Re: Railway (Metrolink - Estuary to Charlemont via Dublin Airport) Order [2022]
Metrolink. Estuary through Swords, Dublin Airport, Ballymun, Glasnevin and City Centre to Charlemont,
Co. Dublin

Re: MetroLink – Railway (MetroLink – Estuary to Claremont via Dublin Airport) Order 2022
Submission made on behalf of Trinity College Dublin
ABP Ref.: NA29N.314724

Please find enclosed a submission on behalf of Trinity College Dublin, the University of Dublin ('Trinity') in respect of the application for approval made by TII for the MetroLink Project under the Transport (Railway Infrastructure) Act 2001, as amended.

Figure 1.1 **Route Alignment: EIAR Options 1 to 4, and Proposed Alternative Option 5**

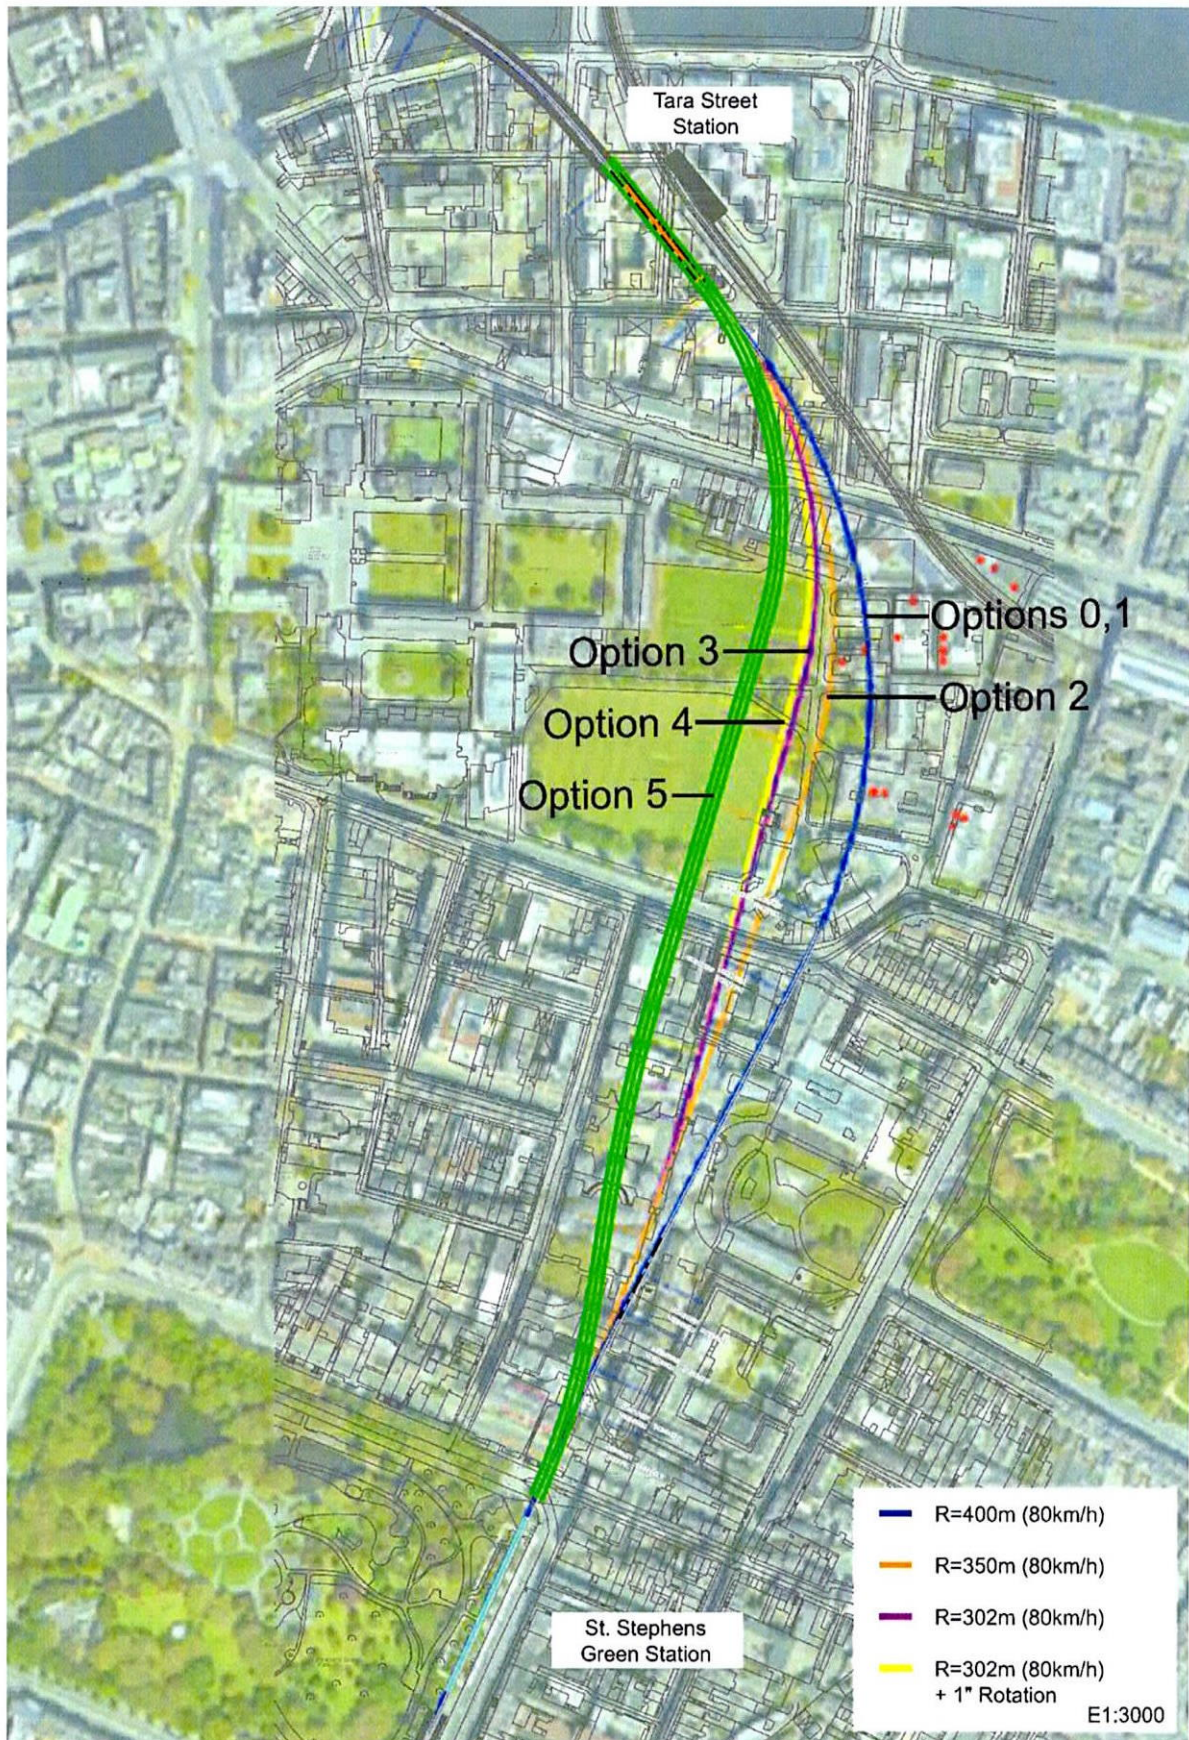
- Mitigation by design with a localised realignment of the line beneath the Campus, identified on Figure 1.1 below as 'Alignment Option 5', moving the alignment 61.5 m westward of the current proposed alignment; and
- Further detail and assessment provided by the Applicant, by way of response to a Request for Further Information issued by the Board, in respect of the Mitigation Measures proposed in the EIAR, as supplemented in this submission by Trinity's experts, to demonstrate to the satisfaction of the Board (and Trinity) the efficacy and practicality of those measures based on robust survey data, monitoring, assessment, and evidence of successful comparators, **based on the Option 5 Alignment.**

As noted, this submission presents evidence for Option 5 as a reasonable alternative to reduce significant impacts that should be considered. Option 5 has been considered by Trinity's experts and there is no apparent planning, technical or engineering reason which would preclude the Board from considering this route option. In order to do so, however, the Board should request TII to provide all necessary information to enable a complete assessment of this route alignment. This is further addressed in Section 4.1.

Figure 1 - Area 306 Proposed Alignment Drawings at TCD

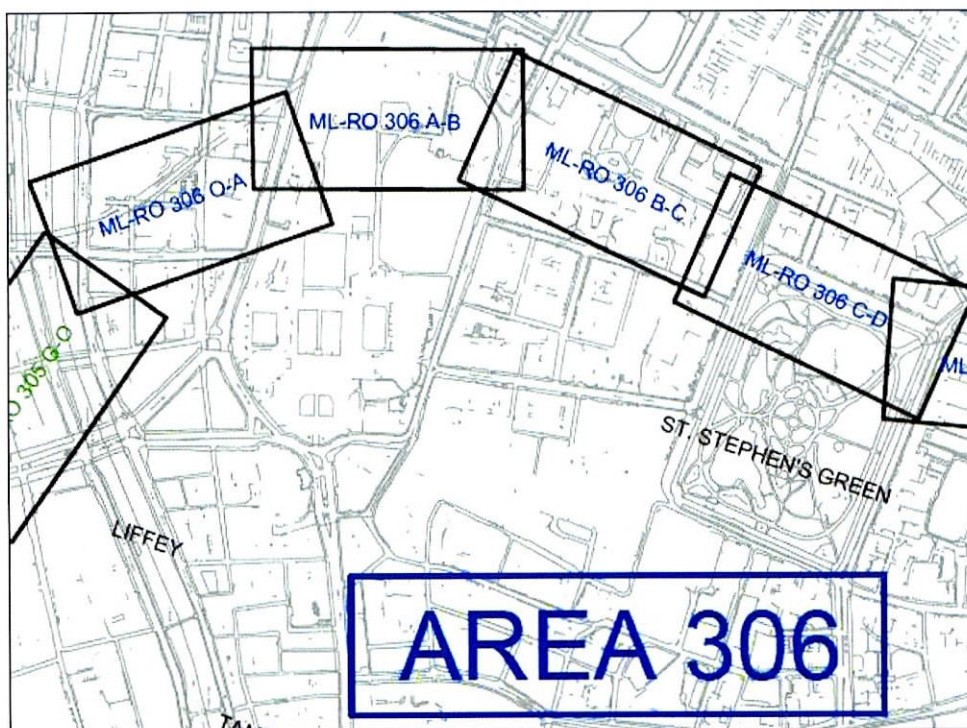
The proposed alignment of the tunnel at Trinity College Dublin (TCD) is provided at Section 4 - Railway Order Plans and Drawings - Alignment Details Book 2 of 2 Dublin City Council. The alignment at TCD is included in what the order describes as Area 306. Figure 1 is extracted from Book 2 and shows that we need to consult four of the drawing sheets to understand the proposed alignment at TCD which runs between Tara St Station and St. Stephen's Green Station. The alignment of the Tara St Station is shown on sheet ML-RO 306 O-A and St. Stephen's Green is shown on sheet ML-RO-306 C-D.

Figure 4 - Extract of Figure 2.1 from Alignment Options Assessment Report (Option 5 added)

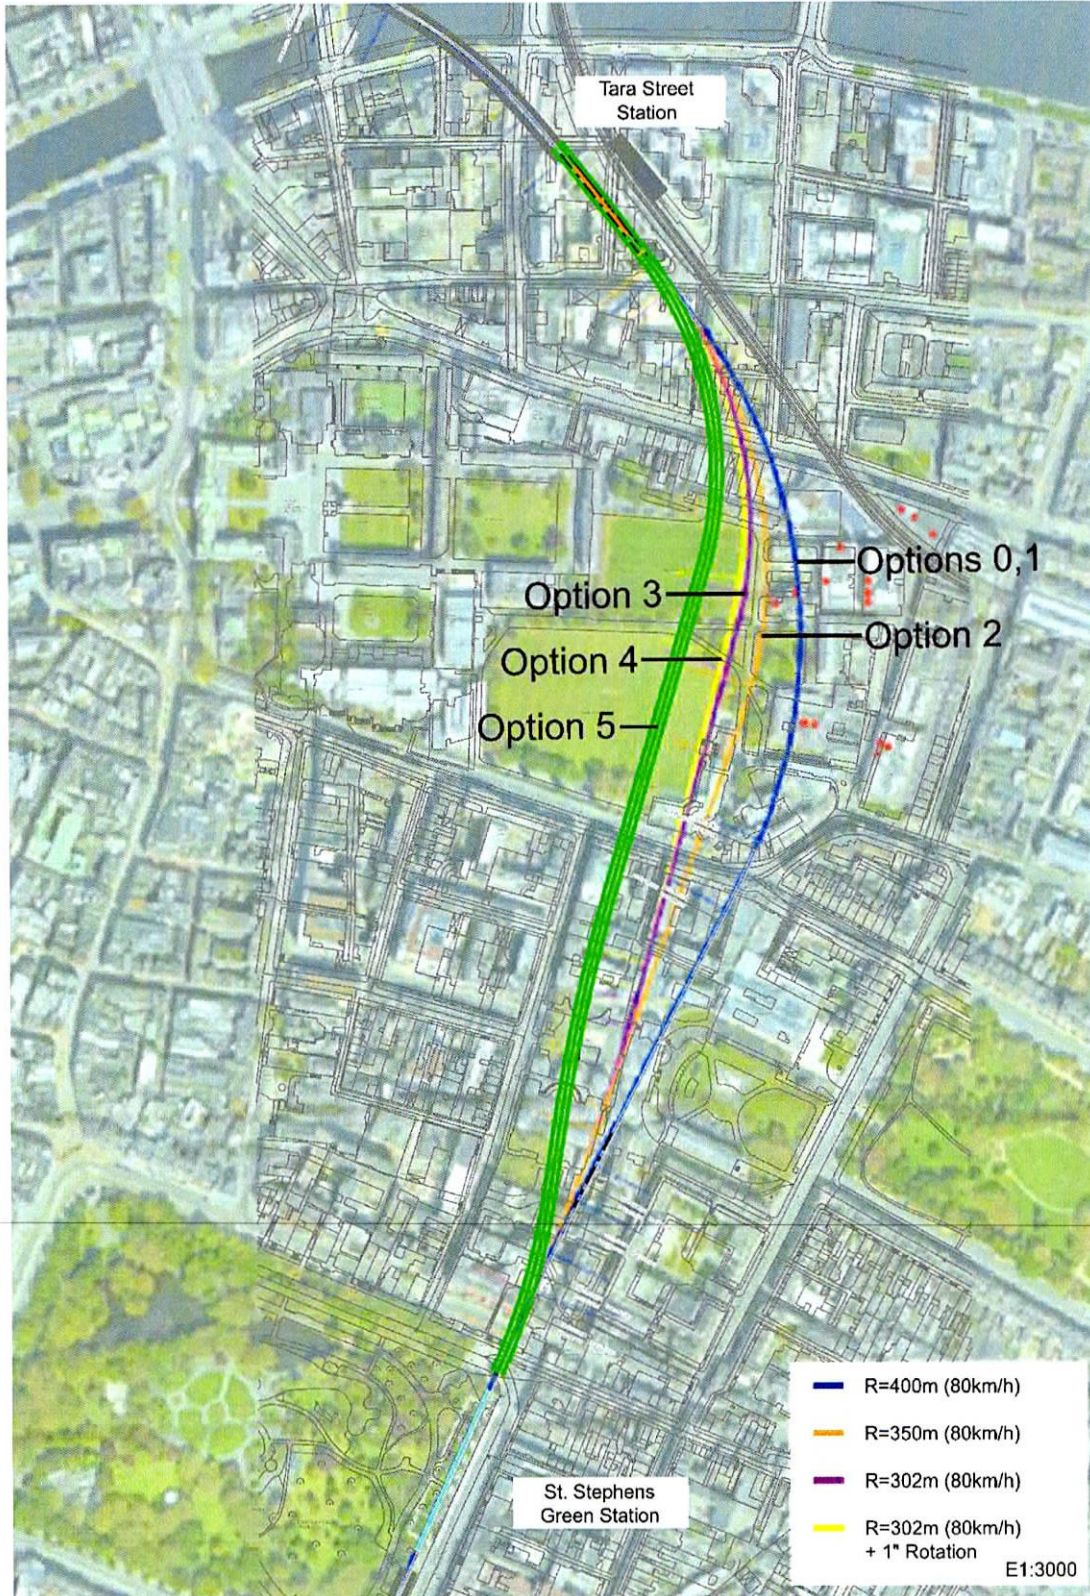
Metrolink's conclusion from this options assessment exercise was to select the Option 2 route as their preferred option. As discussed above, these drawings (albeit in PDF format) have been made available in Section 4 of the Order. We have converted these PDF drawings to vector files and imported them into CAD, and have produced a sketch of an overlay of the stitched together detailed alignment drawings with the image contained within Metrolink's Options Assessment Report (Figure 5). This confirms that the selected alignment corresponds with the orange line of Option 2.

Figure 12 - Longitudinal geological section (South of Tara St Station) with the correct vertical alignment of the tunnel

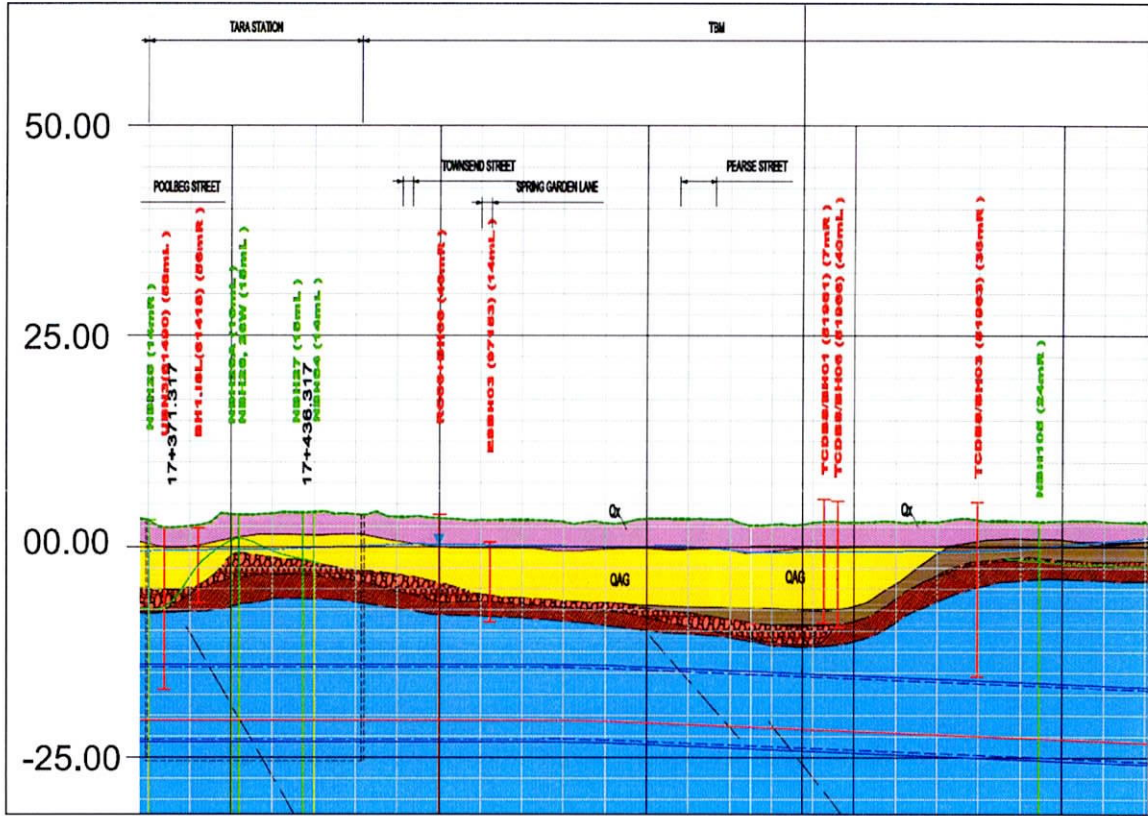
Chapter 20 of the EIAR contains information on the geology and on Metrolink's predicted ground settlements along the route. At the point of reduced rock cover (circa chainage 17+675), a significant localised increase in settlement is predicted by Metrolink as shown in Figure 11. The maximum predicted settlement at this location is 60mm. Unfortunately this analysis has been undertaken on an out of date alignment and hence the high predicted settlements are simply wrong.

We have therefore produced a corrected longitudinal section showing the correct vertical elevation of the tunnel. An extract from this drawing is shown in Figure 12.

The minimum rock cover still occurs at chainage 17+675 but with the correct vertical alignment, the cross-section at this location (Figure 13) now shows a healthy amount of competent rock cover above the tunnel. In such ground conditions, we predict that negligible settlement will be experienced and that the risk to the built environment will also be negligible.

Figure 13 - Geological cross section at point of minimum rock cover (17+675)

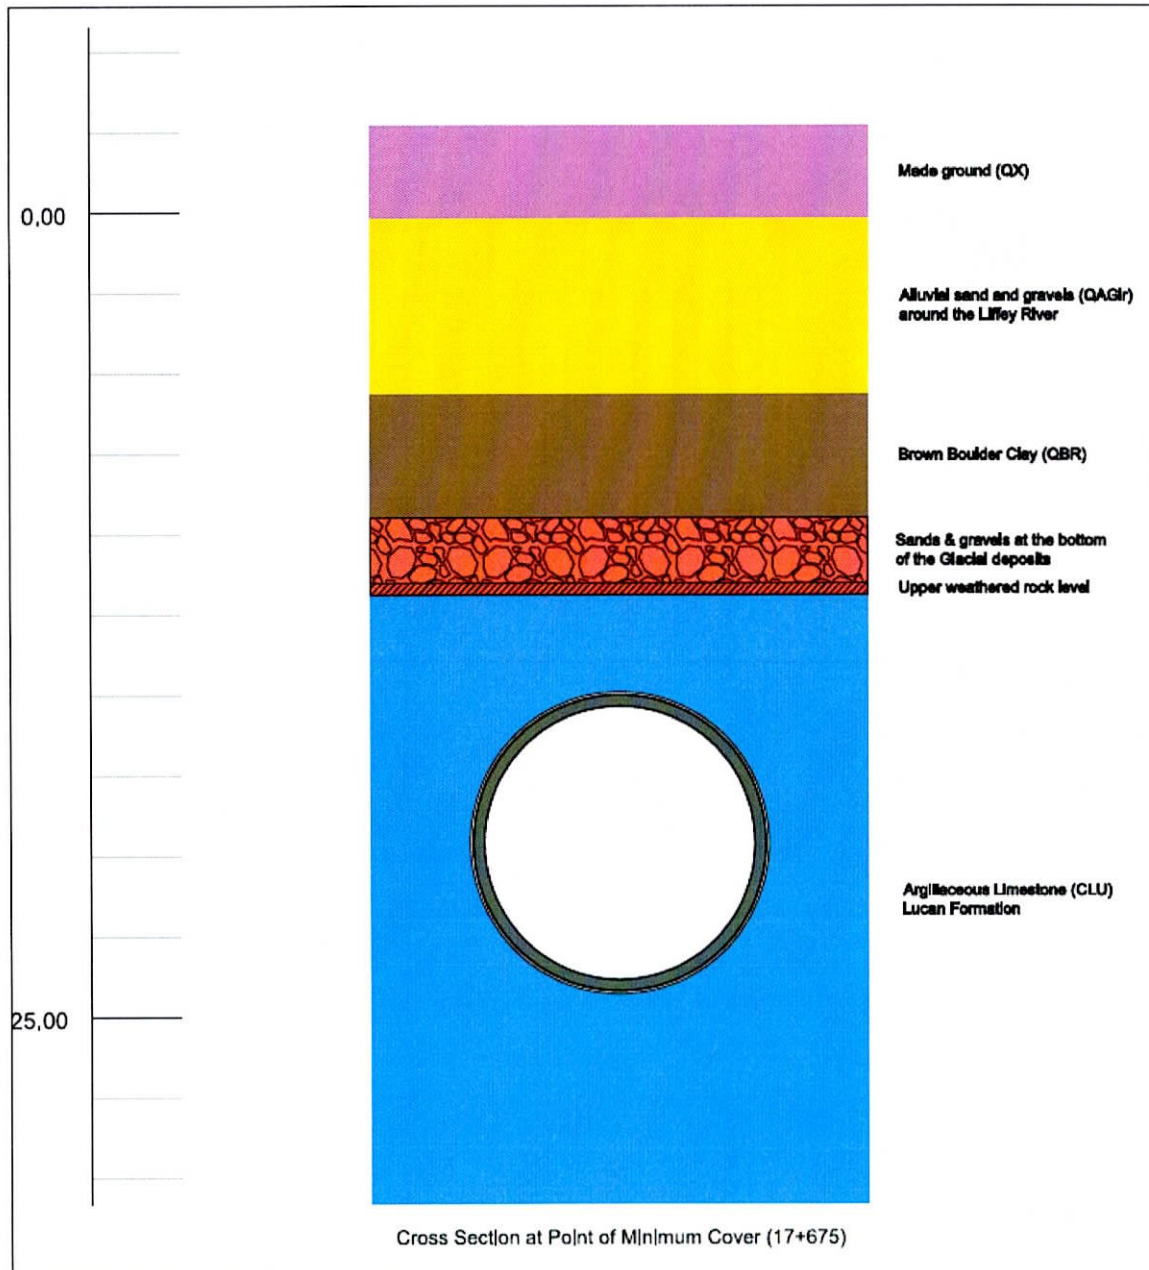
In conclusion, we do not accept that construction of the tunnel on a tighter radius will increase settlements. Furthermore, it should also be recognised that a more Westerly route moves some of the tunnel from beneath the buildings into the playing fields thereby further reducing the risk to the existing built environment.

Figure 14 - Tara St. Station rotated by one degree

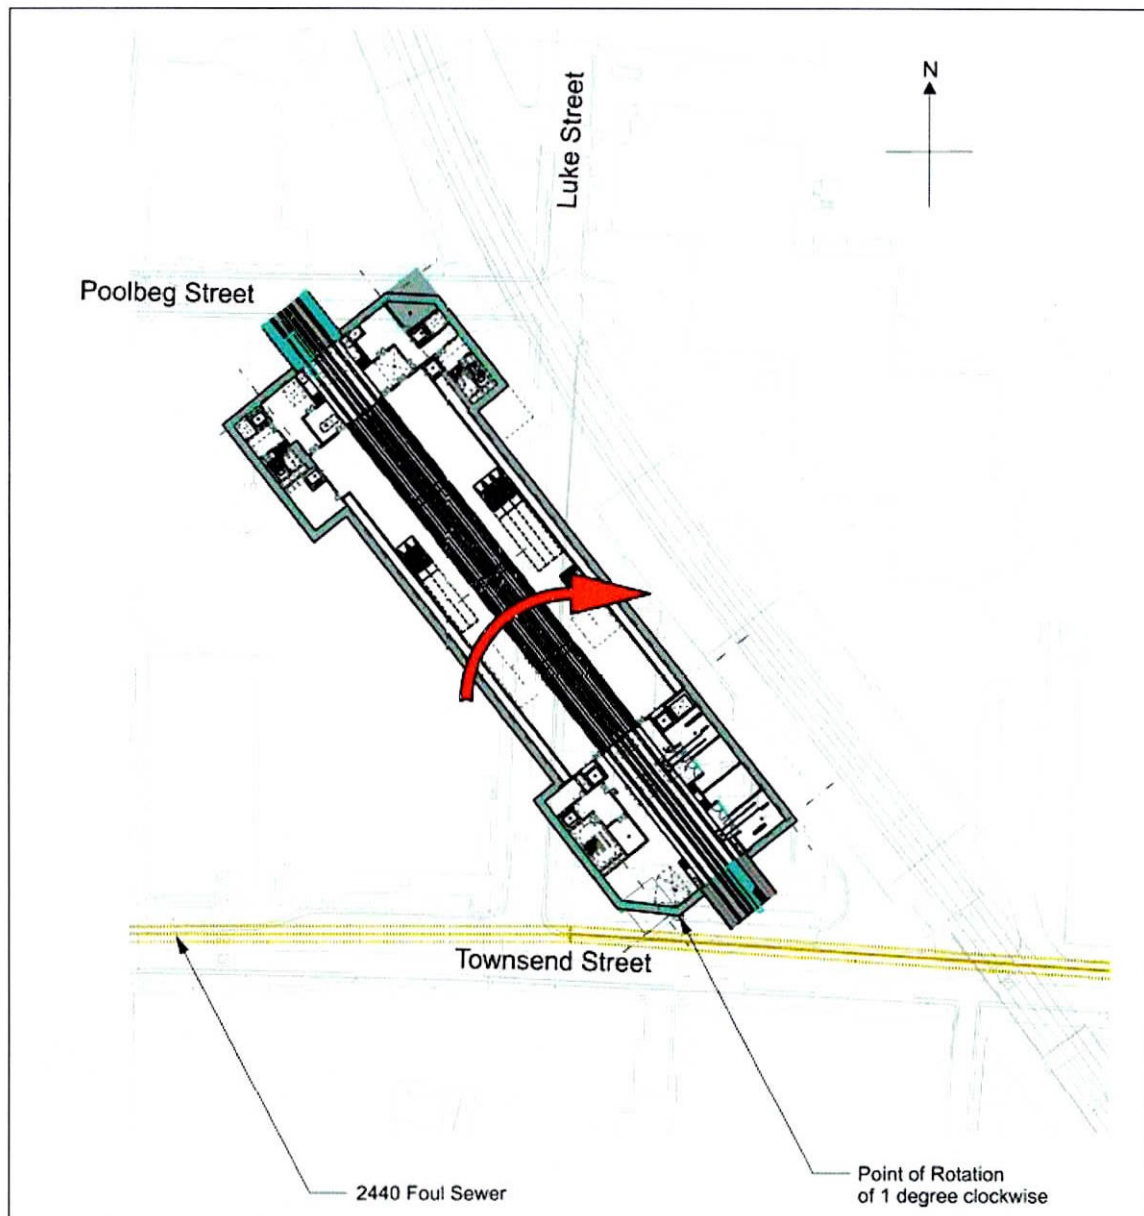
- One-degree clockwise rotation of Tara St Station
- Reducing the minimum design radius to 260m
- Reducing the operational speed to 60 km/h

The proposed rotation of Tara St Station will be undertaken from a point of rotation on the Southern end of the station box. This therefore maintains exactly the same separation between the station box and the 2440mm foul sewer that runs beneath Townsend Street. The rotated station is shown in Figure 14.

Figure 1: TII's proposed route alignment options with TCD's proposed Option 5

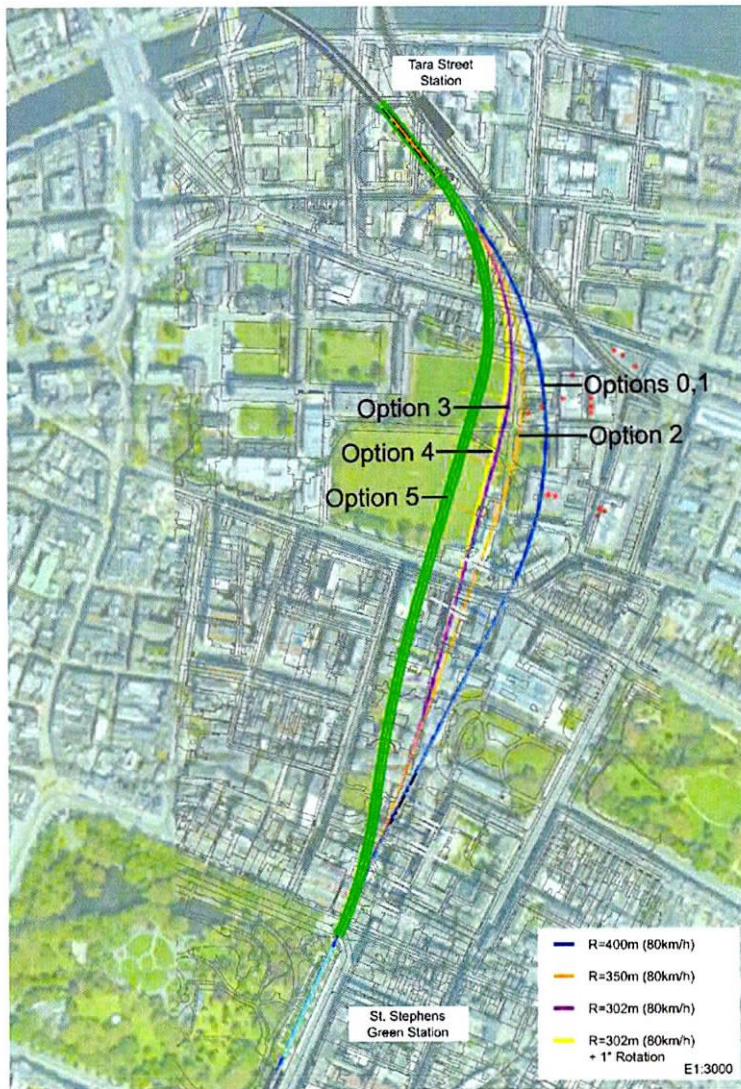
Subsequently, TII considered four other options that moved the alignment a short distance west and so slightly further away from the sensitive facilities and in two cases these options included a train speed reduction. Of these options, the EIAR focuses on 'Option 2'. Improved vibration isolation to the track has also been proposed. TCD has also suggested Option 5, that would move the alignment further west without impacting on TII's proposed Tara station. These six route options are illustrated in Figure 1.

This report presents Arup's appraisal, based on the information currently available, of the likely significant vibration effects from the design proposals presented in the EIAR and assesses the risks of these proposals to the sensitive facilities on TCD's campus. Consideration is given to the risks presented during both the construction and operation phases (i.e. vibration caused by train movements) of the proposed scheme. Impacts from TCD's proposed Option 5 are also assessed and compared.
